Date: April 18, 2022
To: All Prospective Bidders
From: Sam Li
Deputy Director for Purchasing
Re: Addendum Number 4
RFQ C1543 – CoEd Residence Hall Bathroom Renovations Floors 9 - 10

PROJECT:
CO-ED RESIDENCE HALL BATHROOM RENOVATIONS - 9TH-10TH FLOORS
230 WEST 27TH ST
NEW YORK NY 10001

DRAWING TITLE:
9TH FLOOR MECHANICAL PART
PLANS - DEMOLITION AND NEW WORK

8TH & 9TH FLOOR EAST MECHANICAL PART - NEW WORK

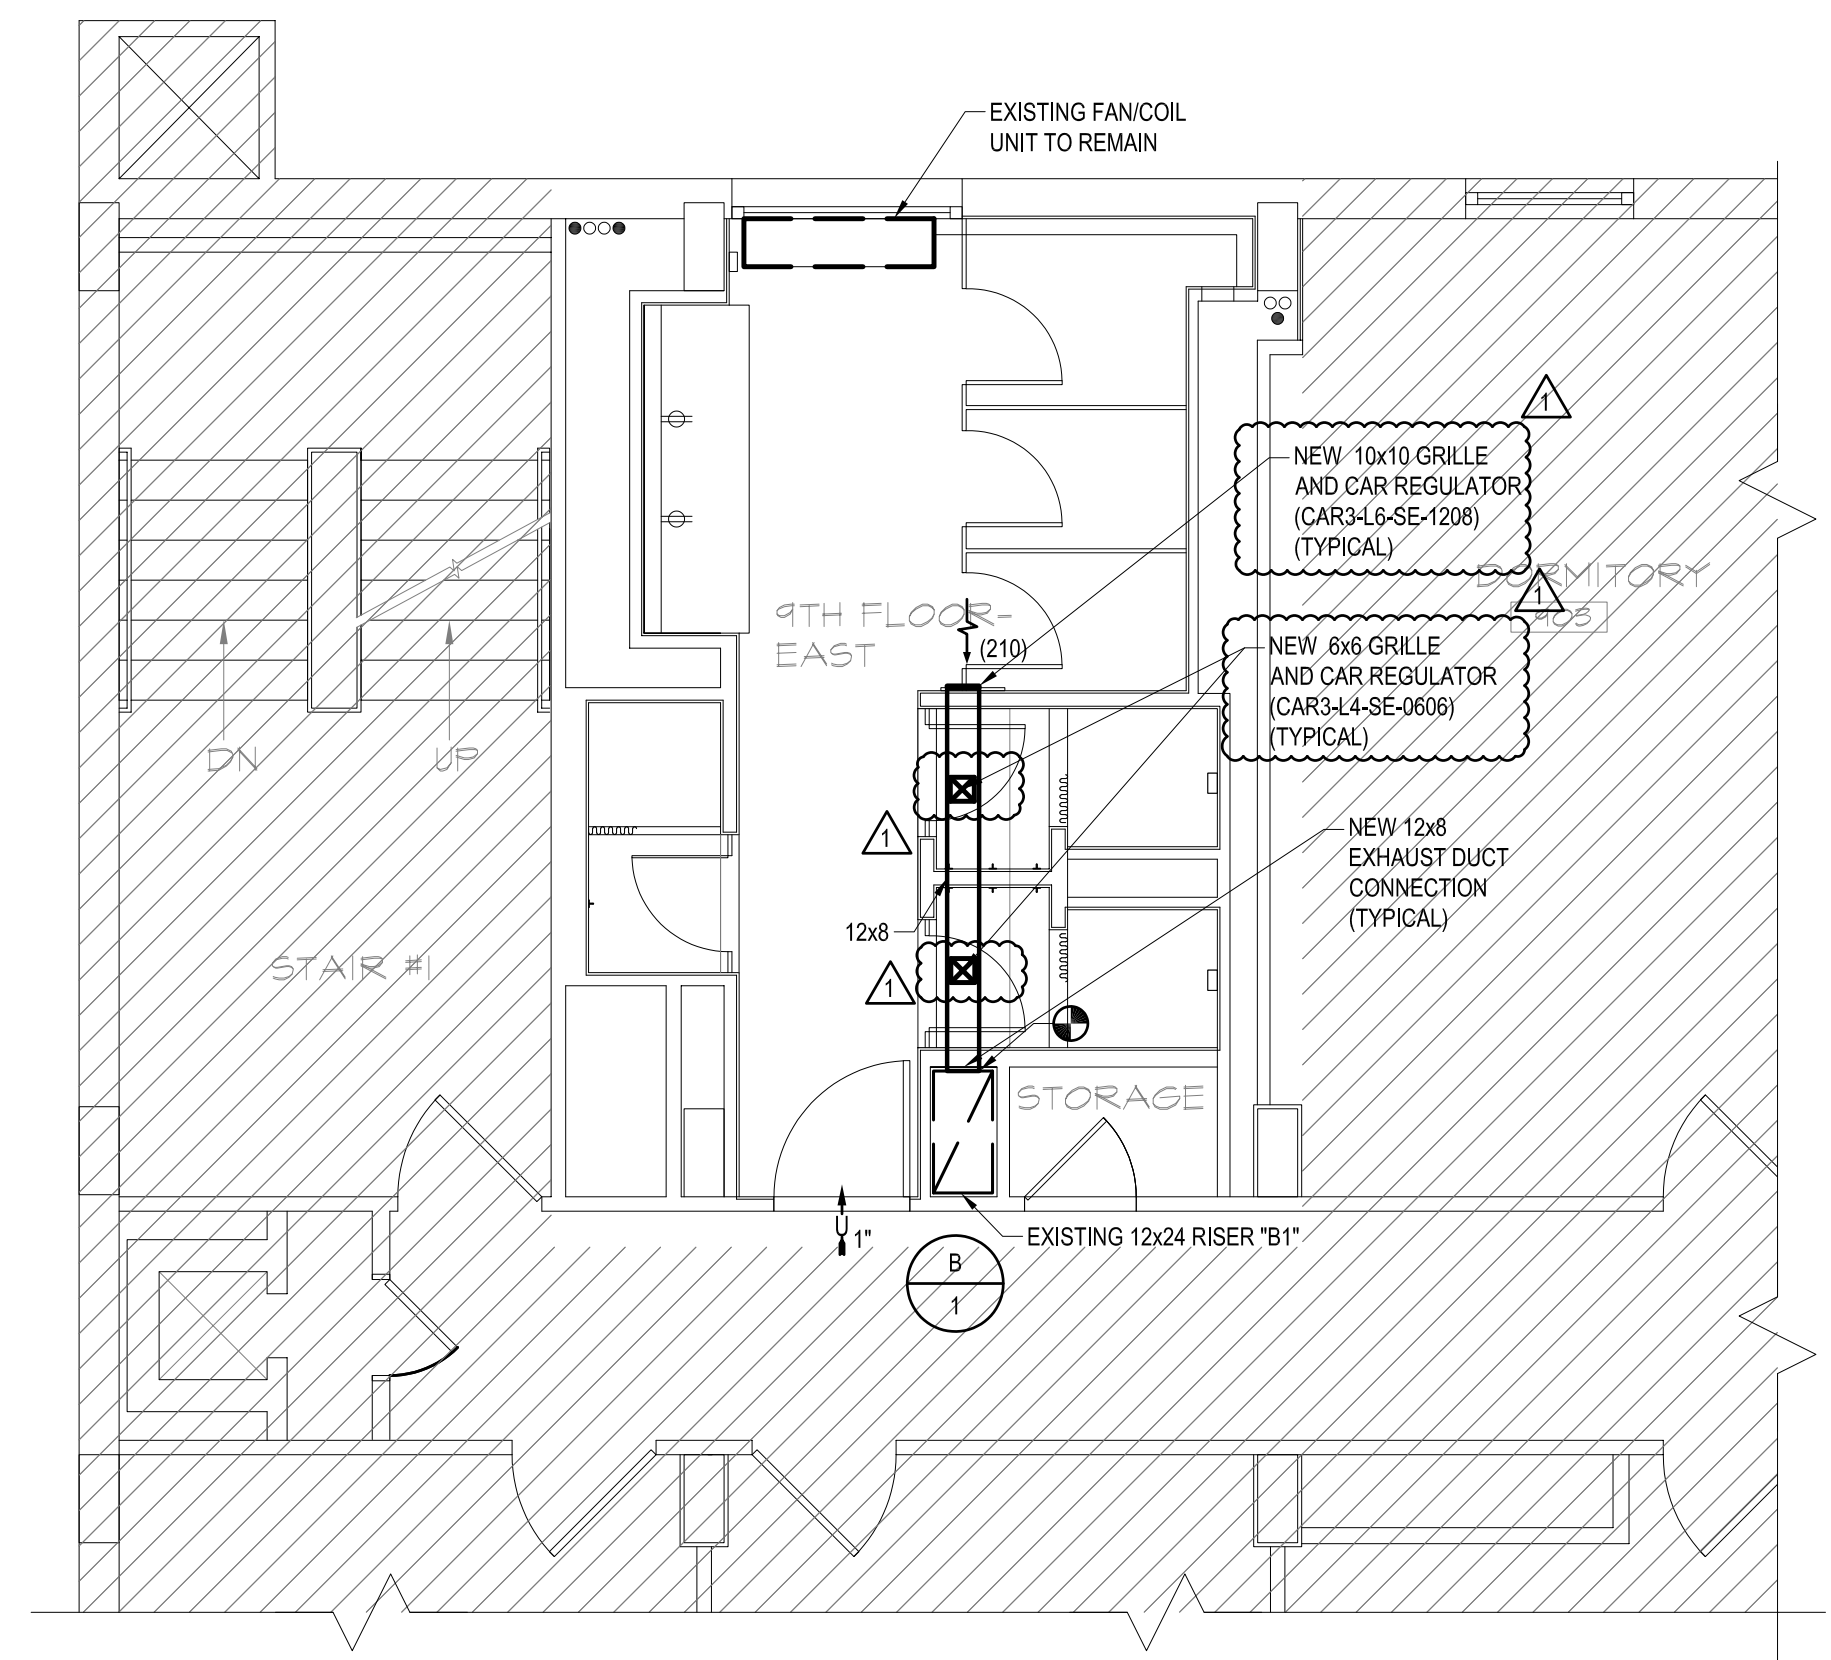
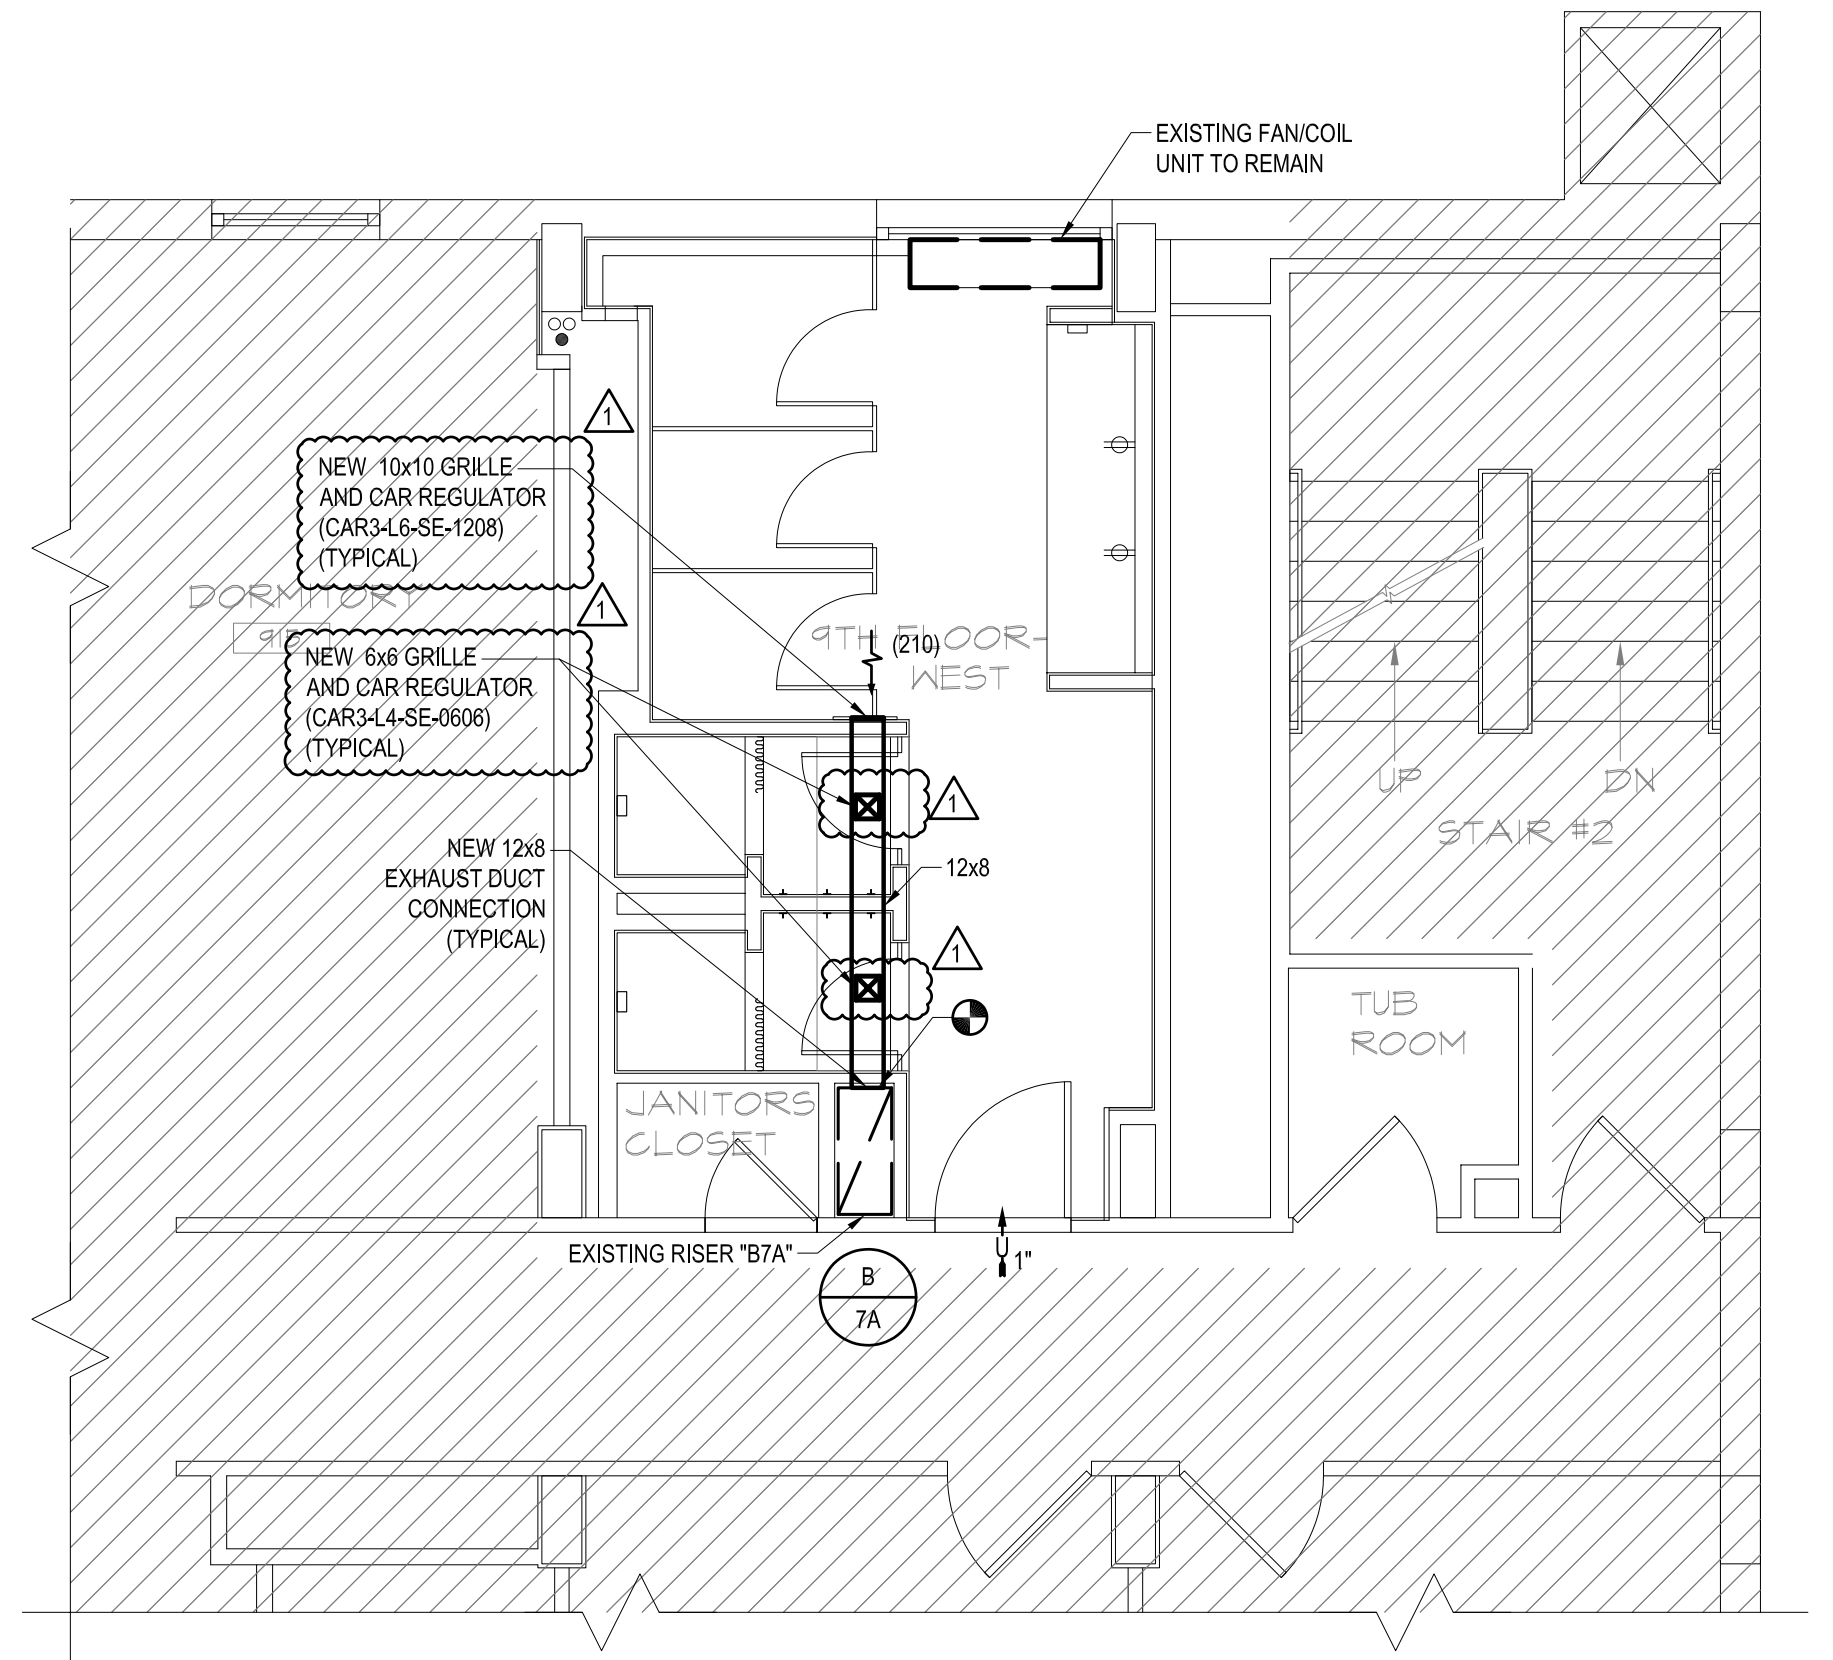
Please find the attached mechanical drawings. As indicated in Addendum #2, new grills are to be installed in the showers of the 8th, 9th & 10th floor.

- NEW WORK NOTES:**
1. INSTALL NEW EXHAUST DUCT AND EXHAUST GRILLE AS SHOWN. CONNECT NEW DUCT TO EXISTING RISER.
 2. EXHAUST GRILLE SHALL BE CAR REGULATOR MODEL CAR3-LV-SE-xxxx AS MANUFACTURED BY ALDES. SEE MODEL ON THE DRAWINGS. COORDINATE THE LOCATION OF THE GRILLE WITH THE ARCHITECTURAL DRAWINGS.
 3. TOILET DOOR SHALL BE 1" UNDERCUT.
 4. THE CONTRACTOR SHALL INSTALL 4 ADDITIONAL CAR3 GRILLES ON THE 8TH FLOOR BATHROOMS SIMILAR TO THE GRILLES INSTALLED ON THE 9TH FLOOR. SEE ARCHITECTURAL DRAWINGS FOR THE LOCATION OF THE GRILLES.
